### APPEAL SUMMARY

**Appeal ID:** 14744

**Project Address:** 1230 SW Park Ave

**Proposed use:** Unmanned telecommunication facility

SHEET NUMBER: A-3  
 REV.: 2

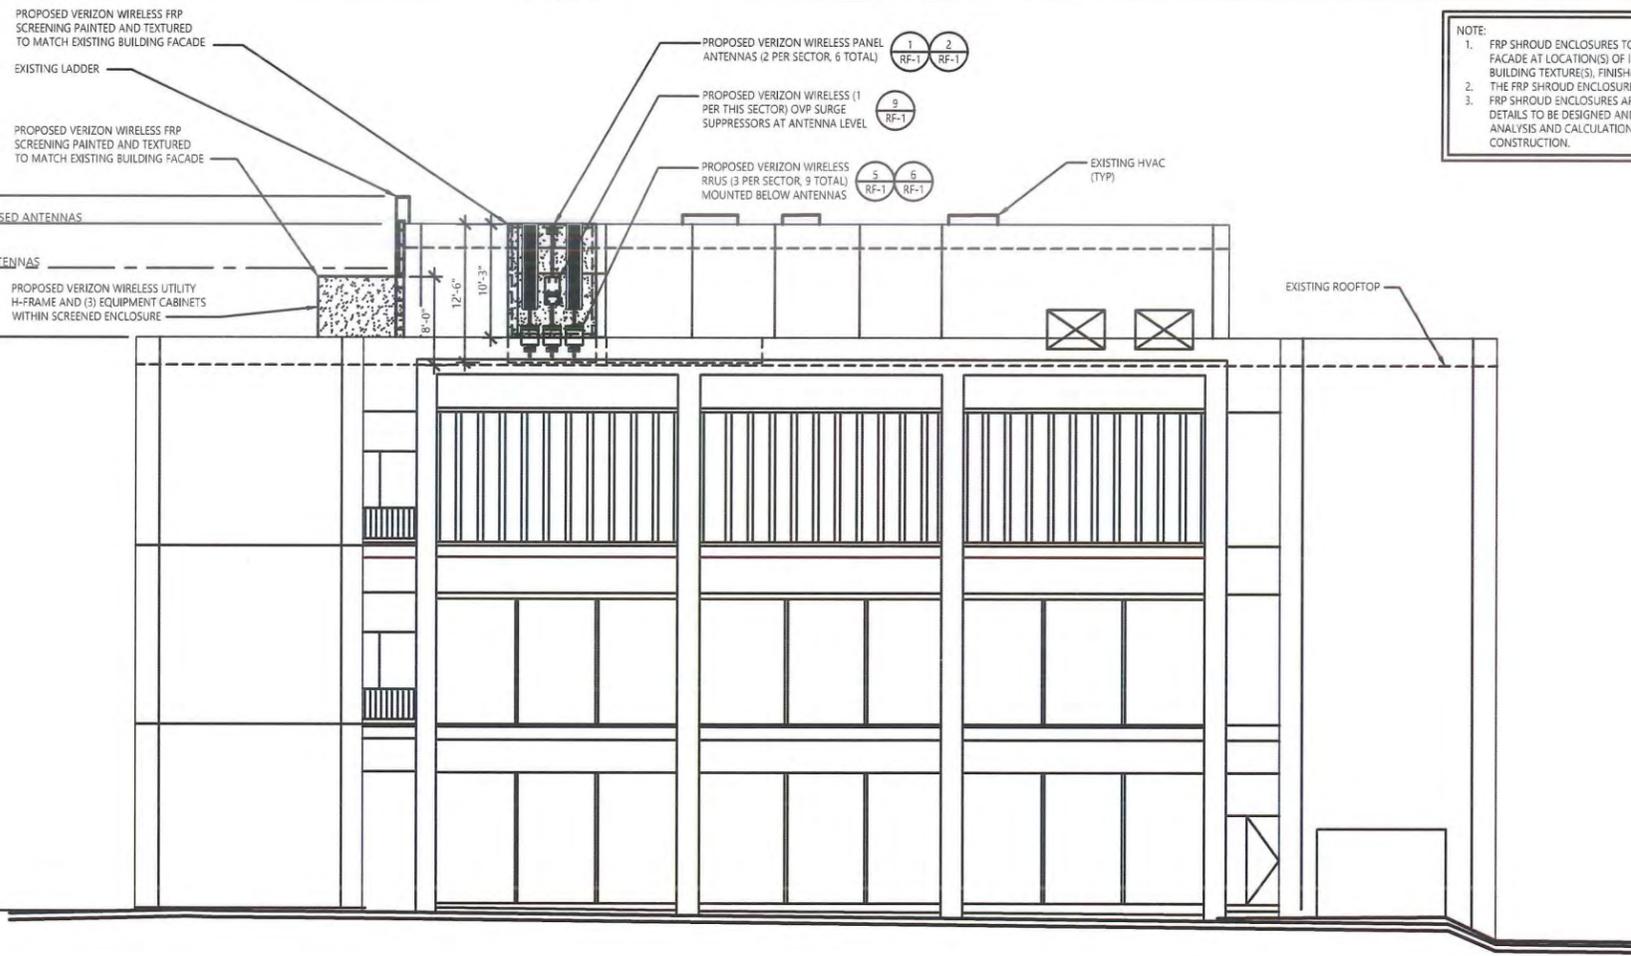
**Requires** Verizon Wireless intends to install an unmanned telecommunications facility to enhance their wireless cellular network. The proposed project includes the screening of proposed antennas on the rooftop of the existing building with proposed equipment in the basement. The project has completed the CUP phase and is moving into permit submittal phase. Per the antenna screening guideline provided by the City of Portland, screening utilizing FRP materials cannot exceed the maximum screen of 10'-0" above the finished roof.

**Proposed Design** As per the CUP LU 16-147440 DZ, the design requirement states that the design must remain symmetrical and architecturally integrated with the rest of the building. Per the FRP screening guidelines the screening must not exceed 25% of the length of the building on the west side. Per the design review we were to install a 28' screening enclosure to meet the design standards. This puts us at 32% of the length of the building on the west side.

**Reason for alternative** The proposed design meets the 10' required set back from property lines and allowable lineal and square footage allotment requirements per City screening guidelines. Proposed screen walls will not block fire access or existing venting. The roof loading has been checked and the existing structure is adequate to support the proposed loading. Proposed screen wall materials will be specified to meet or exceed LA-RR standards requirements for flammability and flame spread. In our opinion, the screen wall will meet the visual screen requirements of the CUP while maintaining the safety requirements of the screening guidelines of the City of Portland. We would like to request pre-permit approval for design purposed to the approval of the proposed finished screen wall with a length of 32% of the overall building length on the West side.

Per the FRP screening guideline regarding the calculation of length of side of screen not exceeding 25% of length of the building on the west side.

As per the CUP LU 16-147440 DZ, The design was also allowed to install a 28'-0" screening enclosure that is mounted on the west side of existing roof top, as long as it was architecturally integrated with the existing penthouse. The new length will be at 32%.

**1. FRP screening width exceeding 25% of the building's wall length: Denied. Extent of enclosure exceeds intent for limited use of FRP material.**

SHEET TITLE:  
**FRP ENCLOSURE**

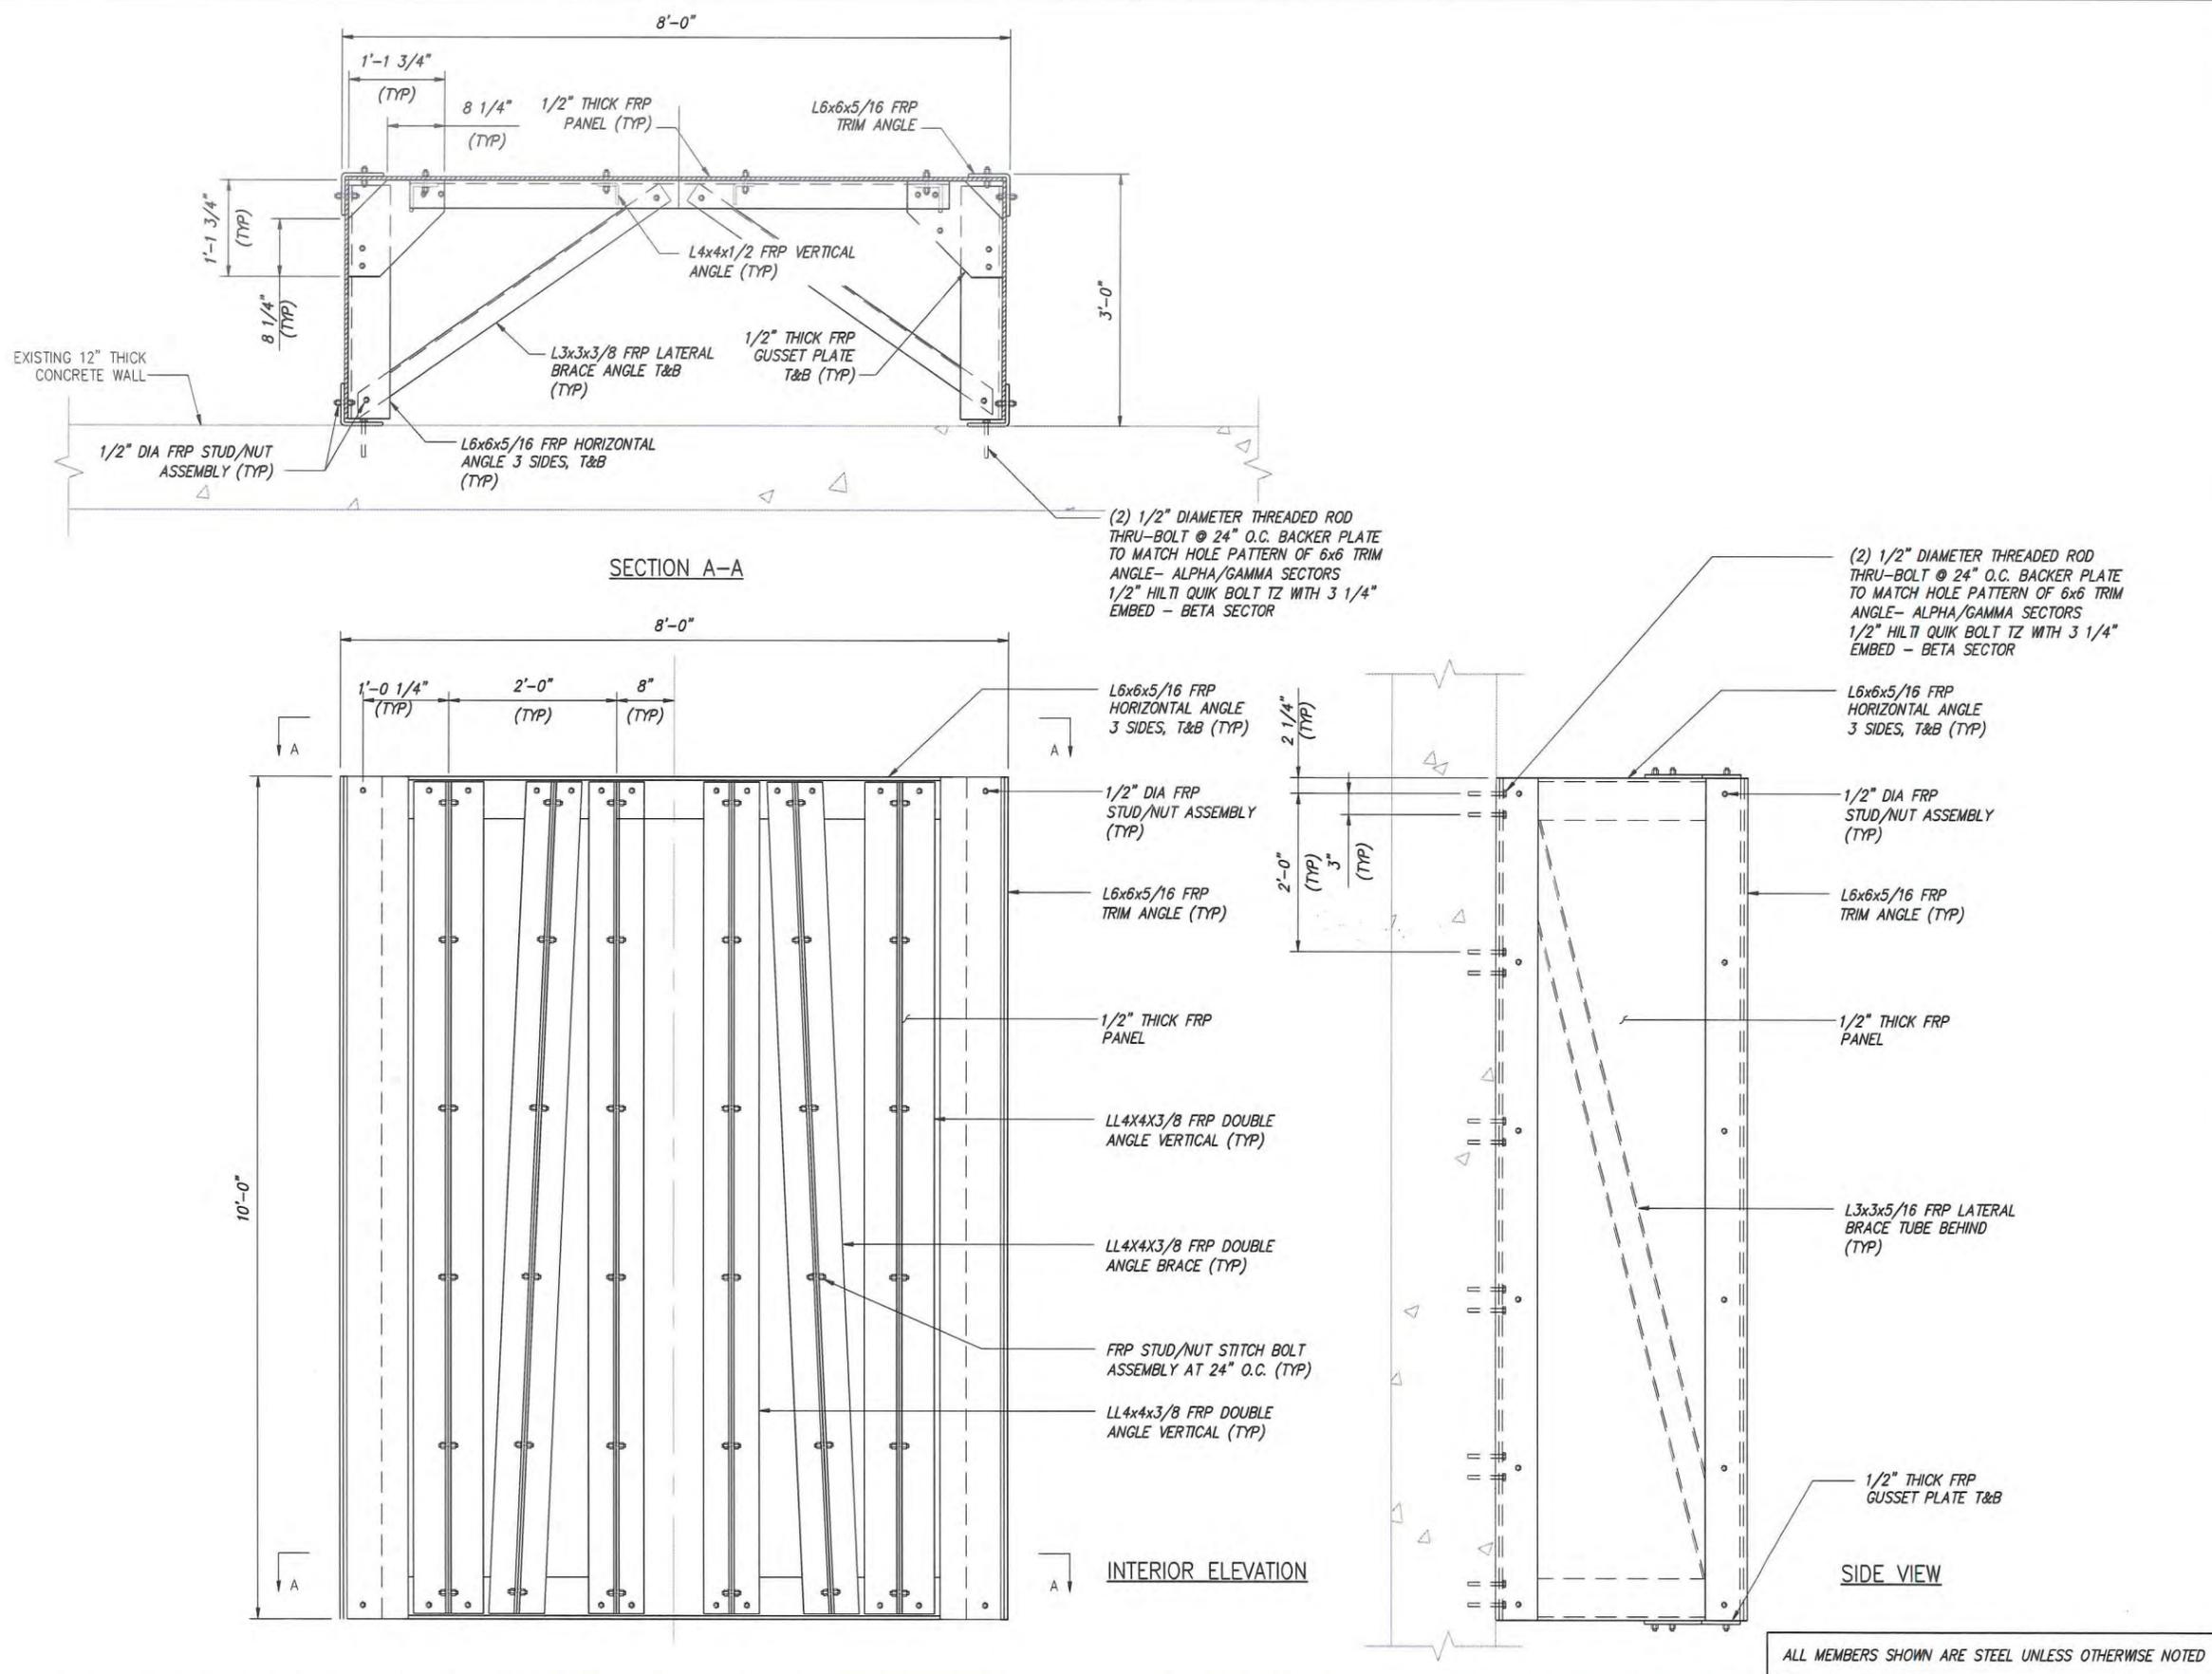
<b>Code Section</b>	Section 2612(8)(7) of the Oregon Structural Specialty Code
<b>Requires</b>	Verizon Wireless intends to install an unmanned telecommunications facility to enhance their wireless cellular network. The proposed project includes the screening of proposed antennas on the rooftop of the existing building with proposed equipment in the basement. The project has completed the CUP phase and is moving into permit submittal phase. Per the antenna screening guideline provided by the City of Portland, screening utilizing FRP materials cannot exceed the maximum screen of 10'-0" above the finished roof.
<b>Proposed Design</b>	As per the CUP LU 16-147440 DZ, the design requirement states the top of the screening shall be equal to the existing elevator penthouse in order to provide symmetrical views from the East and West. The existing elevator penthouse is 12' 9" above the existing finished roof. The finished height of the proposed screening is required to be 12' 9" in order to match the existing elevator penthouse structure. Per the attached cross section of the proposed screen wall design, the FRP screen face material will be 12' 6" in vertical height but will be finished out at 12' 9" above the existing roof deck. A 3" gap at the base of the screen structure will allow for storm water to drain and organized passage of cabling under the screen while the existing parapet beyond will provide the additional visual screening of the antennas.

<b>Reason for alternative</b>	The proposed design meets the 10' required set back from property lines and allowable lineal and square footage allotment requirements per City screening guidelines. Proposed screen walls will not block fire access or existing venting. The roof loading has been checked and the existing structure is adequate to support the proposed loading. Proposed screen wall materials will be specified to meet or exceed LA-RR standards requirements for flammability and flame spread. In our opinion, the screen wall will meet the visual screen requirements of the CUP while maintaining the safety requirements of the screening guidelines of the City of Portland. We would like to request pre-permit approval for design purposed to the approval of the proposed finished screen wall approximately 12' 9" above the existing finished roof.

As per the CUP LU 16-147440 DZ, the design was allowed to install a 12'-6" FRP enclosure on the roof top as long as it was architecturally integrated into the existing building. The new FRP enclosures are to be flush with the existing height of the penthouse.

**2. FRP screening exceeding 10' height: Granted as proposed at 12'-6" on small shrouds.**
